**ZONING AMENDMENT,
& SUBDIVISION STAFF REPORT****Date: April 20, 2006****APPLICANT NAME**

Martha J. Carrio d/b/a Harmony House Salon, Inc.

Martha Carrio's

LOCATION320 South Sage Avenue
(West side of South Sage Avenue, 200'± North of Eslava
Creek Parkway).**CITY COUNCIL
DISTRICT**

SITE PLAN

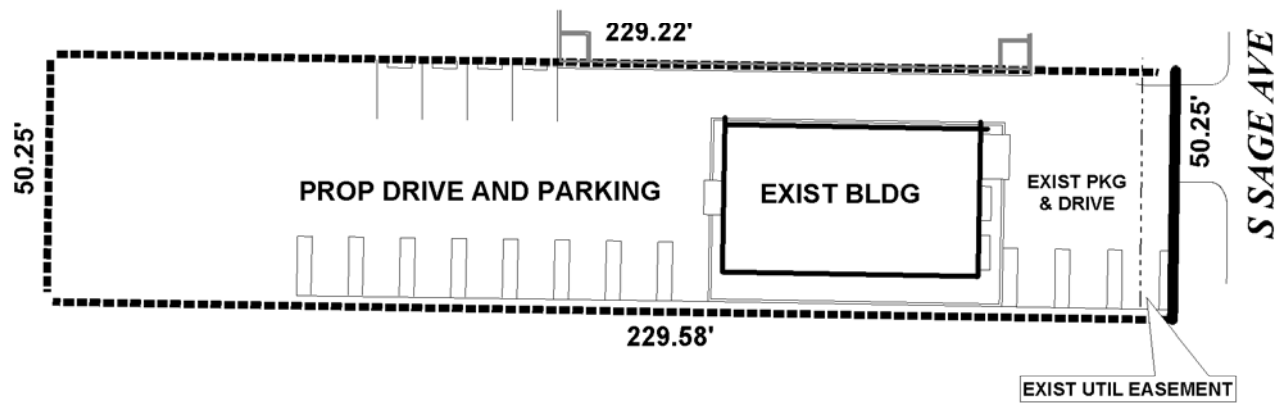
Driveway number, size, location, and design to be approved by Traffic Engineering and conform to AASHTO standards. The plat shows driveway widths and parking stalls lengths below the minimum standard. The minimum driveway width for a commercial site is twenty-four feet and the minimum length of parking stalls as shown is nineteen feet. Changes should be made to accommodate these minimum standards.

The 25-foot minimum building setback line, required in Section V.D.9. of the Subdivision Regulations is not shown for the subdivision, but would be required on the Final Plat, if approved.

It should also be noted that the width of the site and the existing building do not permit a standard width access drive to the rear of the property, where the majority of parking is located.

The existing drive is approximately 12 feet wide where it is constrained by the existing building. The applicant is not proposing to replace or extensively modify the existing building, therefore the applicant will not be able to correct the access problem. Parking in the rear is depicted as double-loaded, 90 degree parking, however, the site is only wide enough to permit 90 degree parking on one side, with the remainder of the width dedicated to a 24-foot wide access drive. The applicant should consult with Traffic Engineering to ensure compliance with the minimum requirements for parking space and access drive design.

Subdivision: With a waiver of Section V.D.3. of the Subdivision Regulations, the Subdivision request is recommended for Tentative Approval, subject to the following conditions: 1) placement of a note on the Final Plat stating that the lot is limited to a maximum of one curb-cut, with the size, location and design to be approved by Traffic Engineering, and conform to AASHTO standards if the existing curb-cut is replaced; and 2) depiction of the 25-foot minimum building setback line.
